PROPOSED CHANGE RTS-197 TO THE DUANE ARNOLD ENERGY CENTER  
TECHNICAL SPECIFICATIONS

The holders of license DPR-49 for the Duane Arnold Energy Center propose to amend Appendix A (Technical Specifications) to said license by deleting certain current pages and replacing them with the attached, new pages. The List of Affected Pages is given below.

Figure 3.6-1: Pressure Versus Minimum Temperature Valid to Sixteen Full Power Years, per Appendix G of 10CFR50

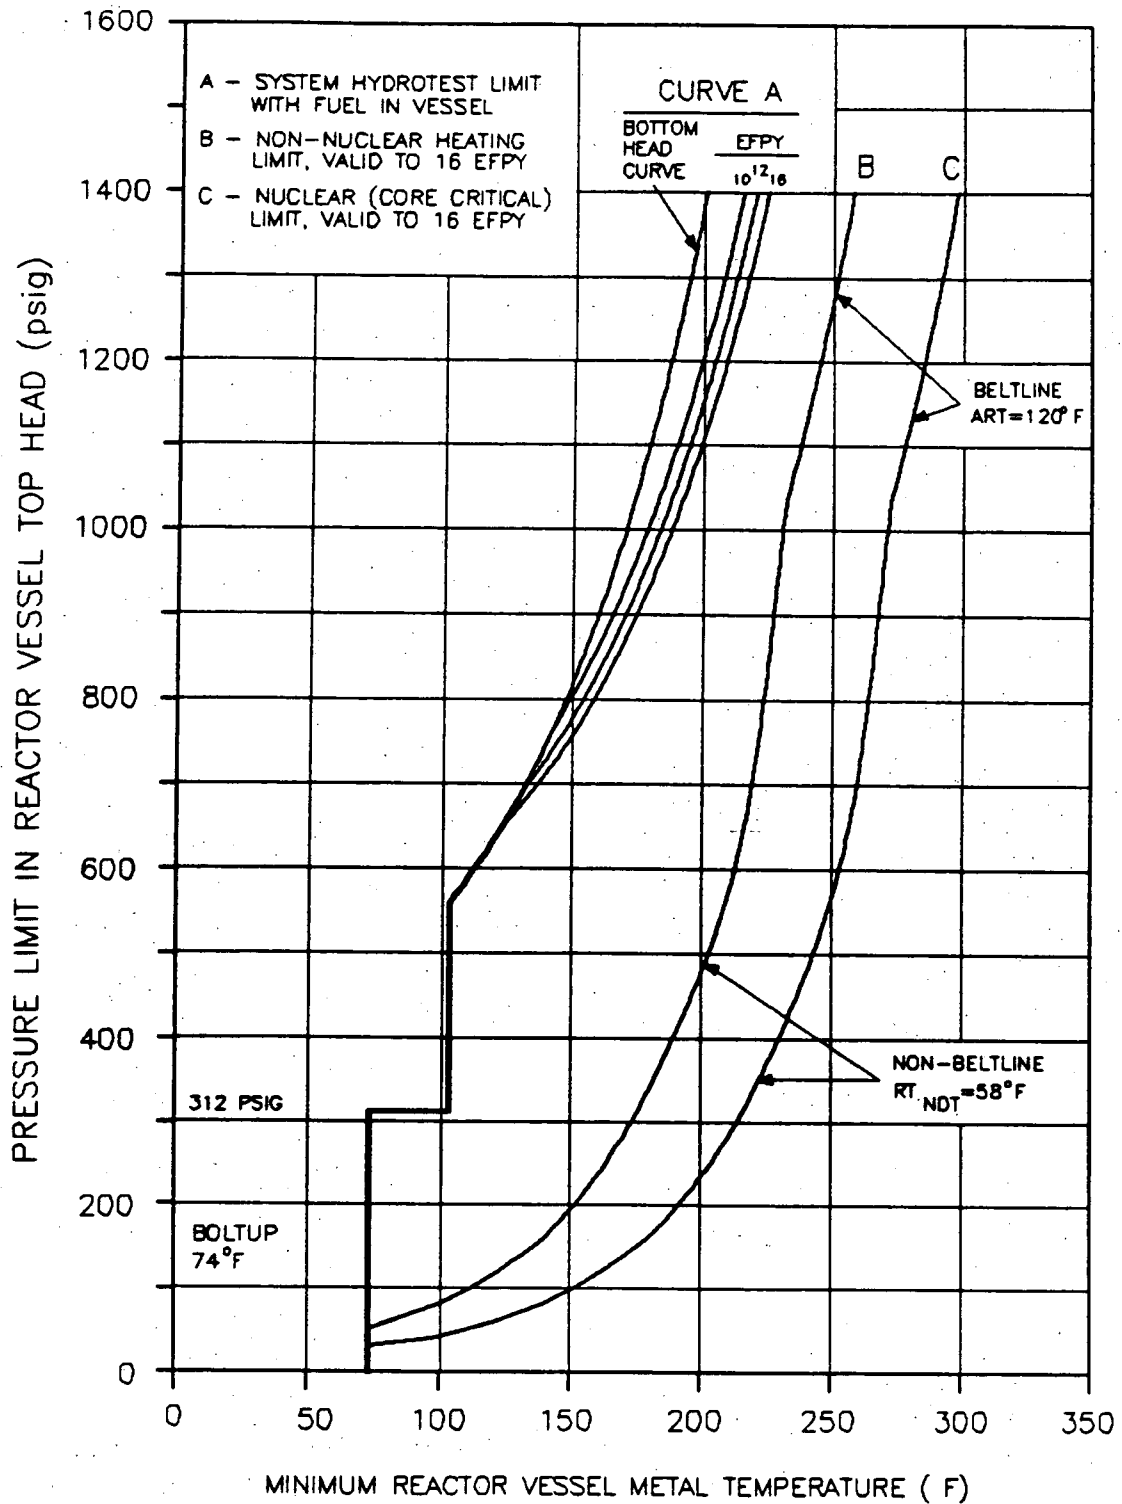
"The reactor vessel shall be vented and power operation shall not be conducted unless the reactor vessel temperature is equal to or greater than that shown in Curve C ~~or of~~ Figure 3.6-1. Operation for hydrostatic or leakage tests, during heatup or cooldown, and with the core critical shall be conducted only when vessel temperature is equal to or above that shown in the appropriate curve of Figure 3.6-1. ~~Figure 3.6-1 is effective through 16 effective full power years. At least six months prior to 16 effective full power years new curves will be submitted.~~"

This LCO currently contains a statement, "Figure 3.6-1 is effective through 16 effective full power years. At least six months prior to 16 effective full power years new curves will be submitted."

- a) This statement is a commitment and not an LCO. This statement does not contain information relative to the immediate operation of the plant or the mitigation of any accident. Information of this nature is typically located in the Bases Section and/or in a commitment tracking system. DAEC is proposing to revise the Bases section to contain this information.

- b) NRC Generic Letter (GL) 91-01, "REMOVAL OF THE SCHEDULE FOR THE WITHDRAWAL OF REACTOR VESSEL MATERIAL SPECIMENS FROM TECHNICAL SPECIFICATIONS" provides guidance for the removal of the specimen schedule and associated language from the TS. The justification for removal is that the TS requirement is a duplication of 10CFR50, Appendix H. The GL also provides that the licensee state in the TS that the specimens be withdrawn in accordance with 10CFR50, Appendix H. The proposed DAEC SR 4.6.A.2 has been revised to comply with the GL. As stated in the GL, the removal of the schedule and language associated with the schedule will not result in any loss of regulatory control.

**"The reactor vessel material specimens shall be removed and examined to determine reactor pressure vessel fluence as a function of time and THERMAL POWER as required by 10CFR50, Appendix H. The results of these fluence determinations shall be used to update Figure 3.6-1."**

The added paragraph simply states that the specimens will be removed and examined in accordance with 10CFR50, Appendix H and that the results of the fluence determinations will be used to update Figure

The revision discussed above is editorial in nature. The existing information does not provide the control room operator with any prudent action or guidance in the operation of the plant or mitigation of any accident and does not affect any procedural steps in the Emergency Operating Procedures. The proposed revision will not result in any loss of regulatory control since DAEC is still maintaining the requirements specified in 10CFR50, Appendix H.
